R22 SERVICE BULLETIN SB-118

R44 SERVICE BULLETIN SB-107

SUBJECT: Fire Extinguisher Relocation

EFFECTIVITY: R22-series and R44-series helicopters with fire extinguisher located forward of left seat tail rotor pedals.

FIGURE 1

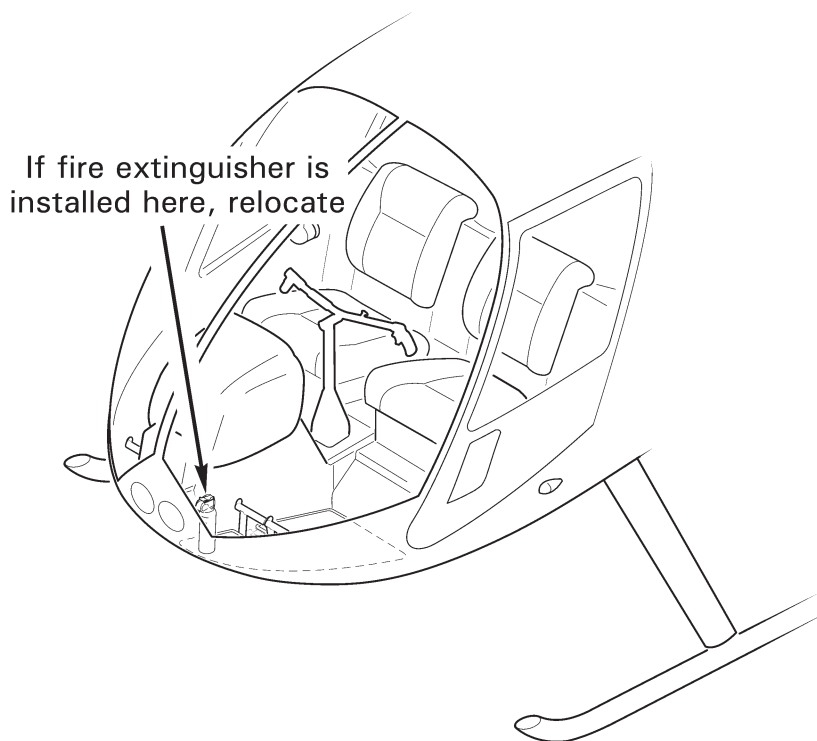
BACKGROUND: RHC has received reports of fire extinguishers either leaking charge or ejecting the top. The problems are suspected to be heat related. This bulletin requires relocating certain extinguishers to lessen heat exposure and ensure that an ejected top will not damage the windshield.

1. Refer to Figure 1. If helicopter has fire extinguisher installed in location shown, order one KI-281-1 (R22) or KI-281-2 (R44) Fire Extinguisher Relocation Kit from RHC Customer Service.

2. Relocate fire extinguisher per kit instructions.
3. Make appropriate maintenance record entries.
